7.6 All Other Instrumentation Systems Required for Safety

The information in this section of the reference ABWR DCD, including all subsections, tables, and figures, is incorporated by reference with the following departures and supplements.

Figure 7.6-4a Basic Configuration of a Typical Neutron Monitoring System Division

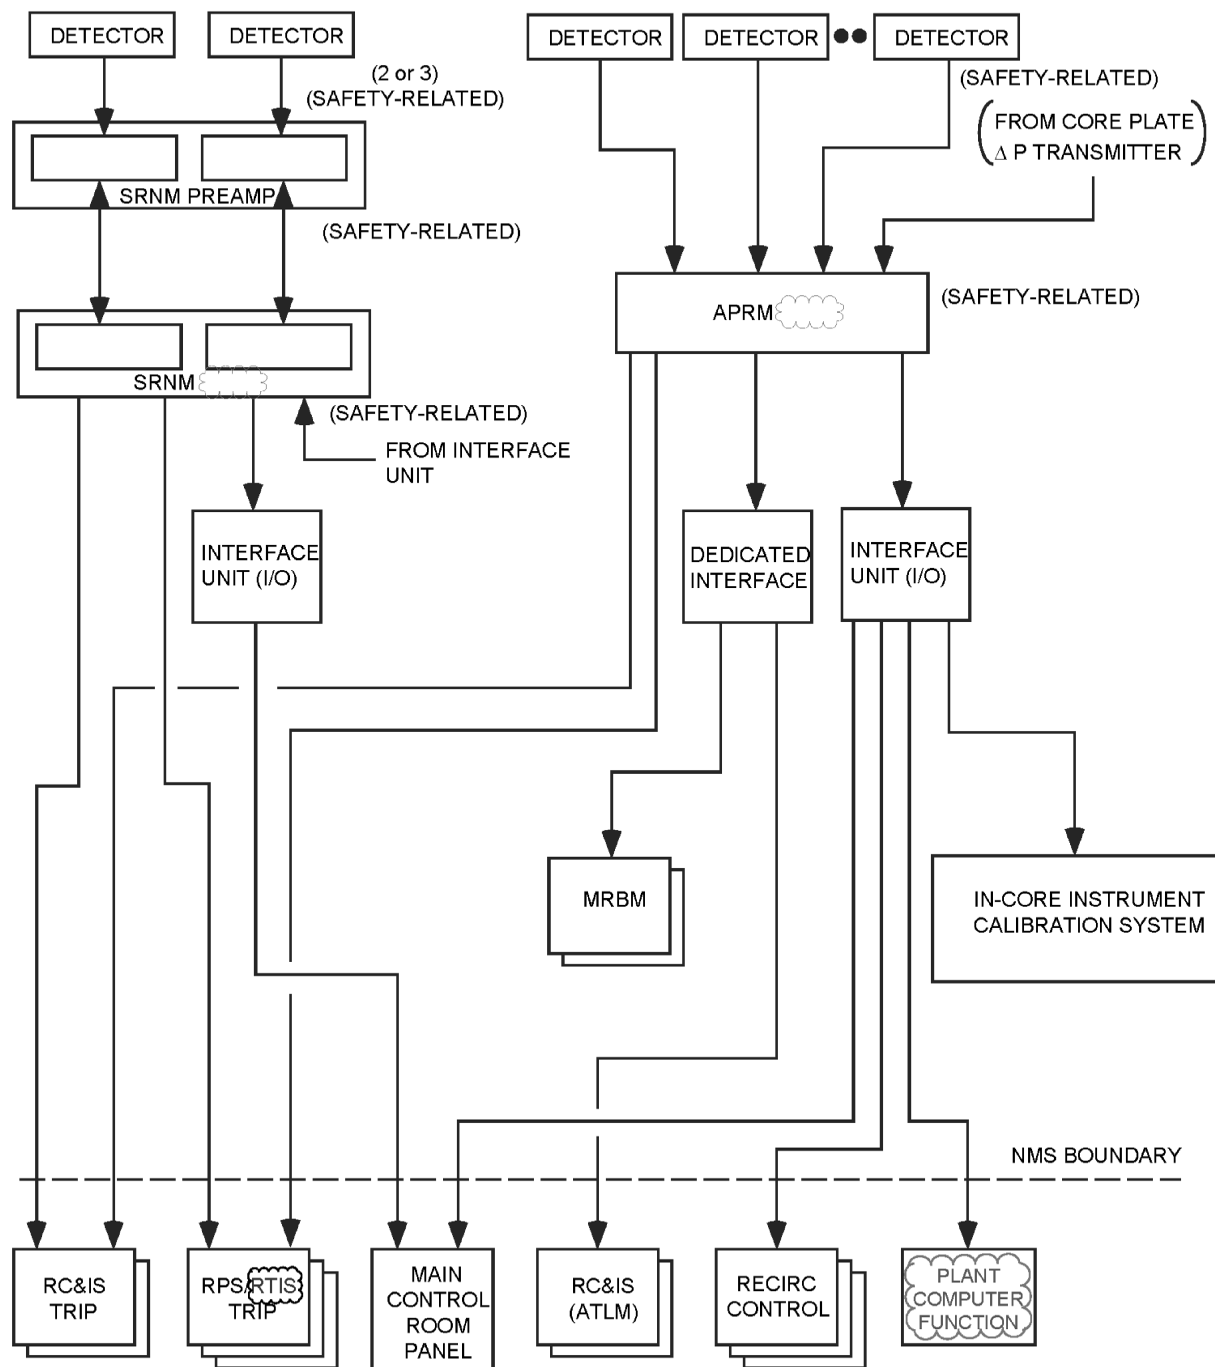
STD DEP T1 3.4-1 (Table 7.6-5 and Figures 7.6-1, 7.6-2, 7.6-4a)

The purpose of the Neutron Monitoring System (NMS) is to monitor power generation and, for the safety function part of the NMS, to provide trip signals to the Reactor Protection System (RPS) to initiate reactor scram under excessive neutron flux (and power) increase condition (high level) or neutron flux fast rising (short period) condition. The NMS also provides power information of operation and control of the reactor to the Plant ~~Process~~ Computer System (PCS) Functions (PCF) and the rod block monitor. A block diagram showing a typical NMS division is shown in Figure 7.6-4a. The operating ranges of the various detectors are shown in Figure 7.6-4b.

Figure 7.6-9 Instrumentation Location Definition for the Suppression Pool Temperature Monitoring System

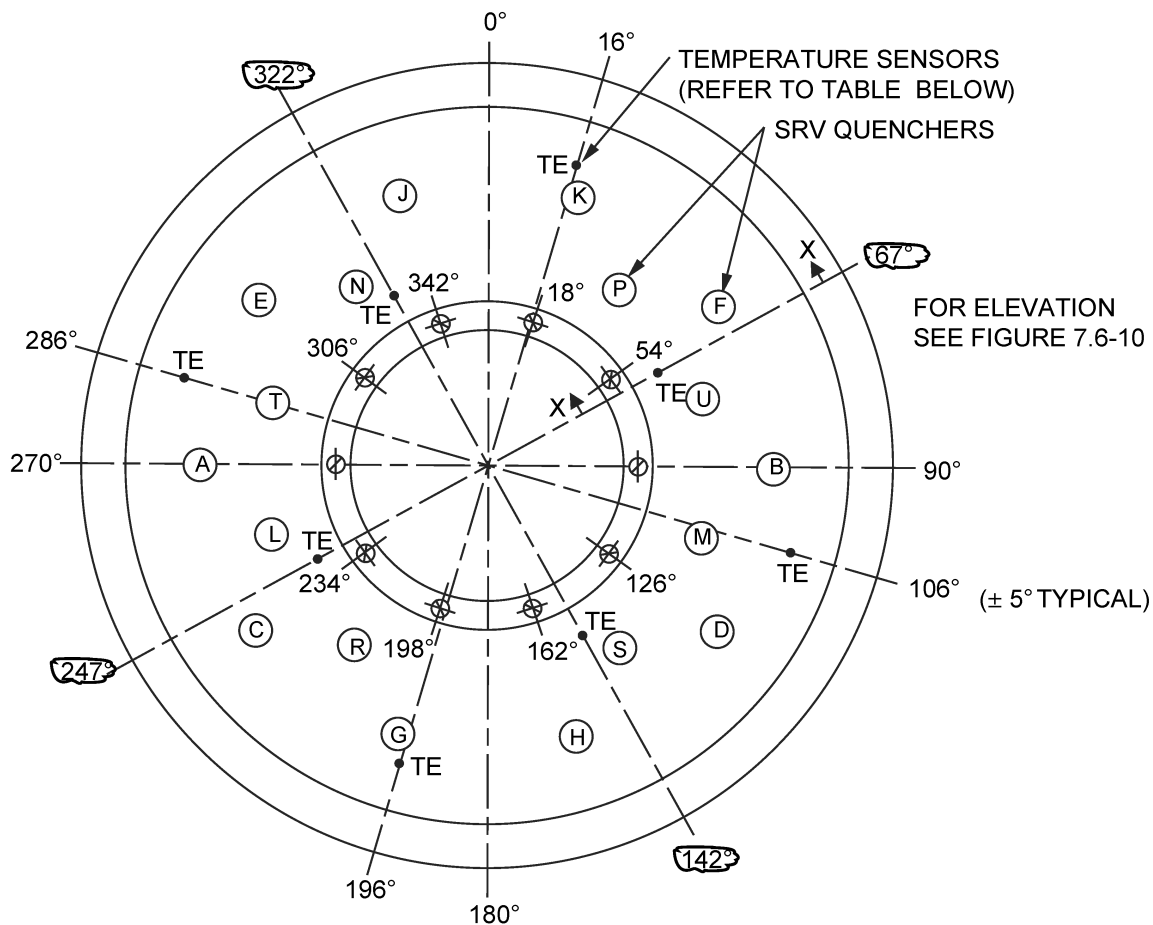
STD DEP 7.6-3 (Figures 7.6-9, 7.6-11)

The SPTM System configuration is shown in Figures 7.6-9 and 7.6-10. There are eight temperature circumferential sensor locations (Figure 7.6-9), which are chosen based upon the following considerations:

- (2) Each SRV discharge line quencher is in direct sight of two sets of temperature sensors within 9 meters.

Figure 7.6-14 OPRM Logic

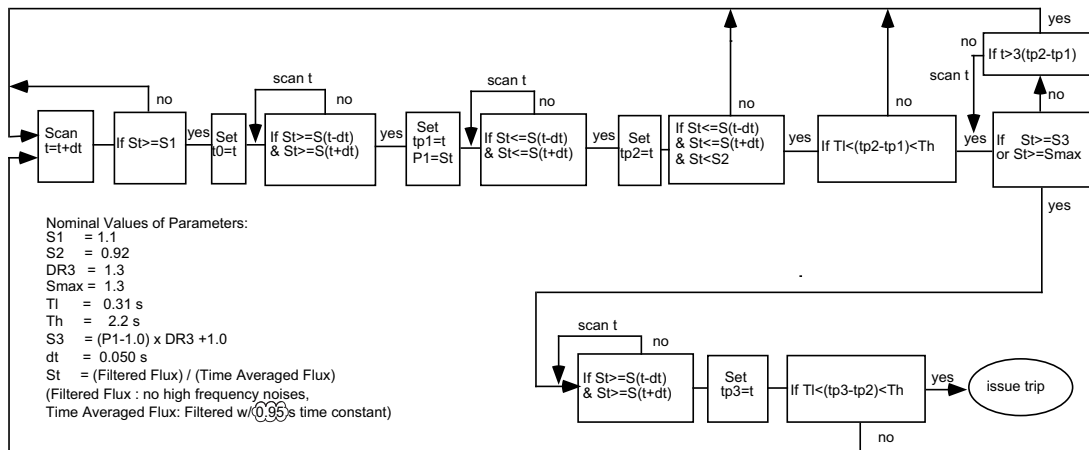
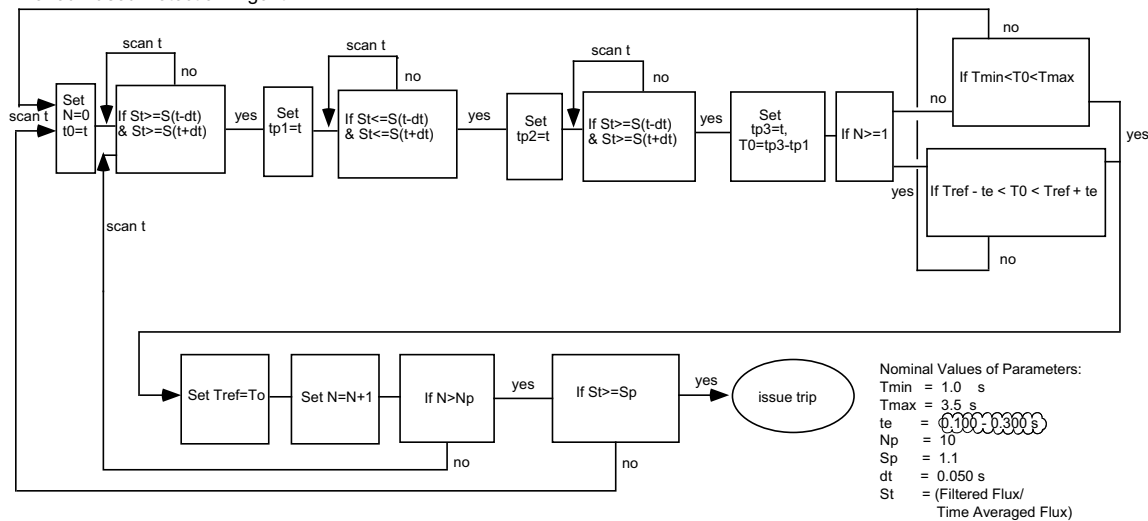
STD DEP 7.6-1 (Table 7.6-2 and Figures 7.6-2, 7.6-14)

For the OPRM trip function, the response signal of any one OPRM cell that satisfies the conditions and criteria of the trip algorithm will cause a trip of the associated OPRM channel. Figure 7.6-14 illustrates the trip algorithm logic. ~~The OPRM trip function does not have its own inoperative trip for insufficient number of total LPRM inputs in the channel. It follows the APRM's inoperative trip of insufficient number of LPRMs.~~ The OPRM function has its own inoperative trip when the channel has less than the required minimum operable cells, when there is an OPRM self-diagnostic fault, when the APRM instrument watchdog timer has timed out, or if there is a loss of power to the APRM instrument.

$T_{\min}=1\text{ s}$, $T_{\max}=3.5\text{ s}$, $\pm t_{\text{error}}=0.15\text{ s}$ **[0.100 - 0.300s]**, $N_P=10$.
 (For details see Figure 7.6-14).
